REFERENCE LHC-EQCOD-EC-XXXX

ENGINEERING CHANGE REQUEST

Installation of Low-Impedance Primary Collimators **with BPMs** (TCPPM) in IR7

Figure 1 — 3D view [5] of the TCPMP collimator. Top: full collimator, with RF fingers. Bottom: sketch with left jaw only to show the 60 cm active length (obtained through blocks of different thickness).

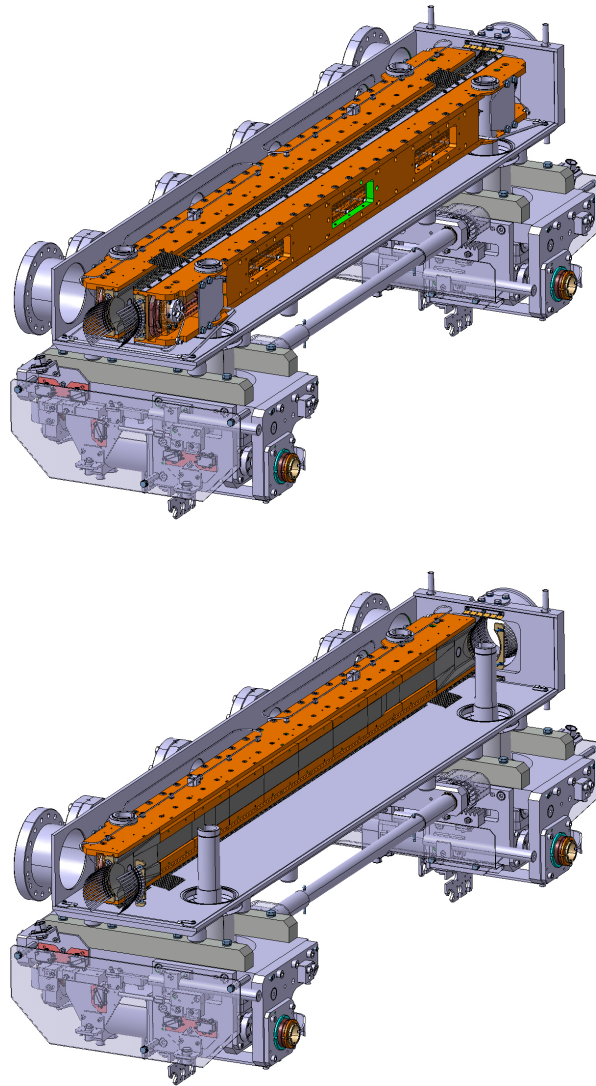
The present TCPPM design [7] (see Figure 1) is similar to the one of the present TCPs [1]; among the most noticeable differences, there are the jaw material and the presence of Beam Position Monitors (BPMs). In fact, the design foresees jaws made of a composite material (MoGr) obtained from Molybdenum and graphite, chosen for its lower impedance and similar robustness with respect to the jaw material of the present TCPs (Carbon-Fiber-Composite, CFC). The new material is characterised by an impedance lower by about a factor 2 with respect to the one of CFC. The collimator jaws are equipped with BPM button pick-ups, for an easy determination of the beam closed orbit at the collimator and fast and precise alignment of the jaws. A third BPM is installed on the tank, to measure the beam position on the axis orthogonal to the one of cleaning.
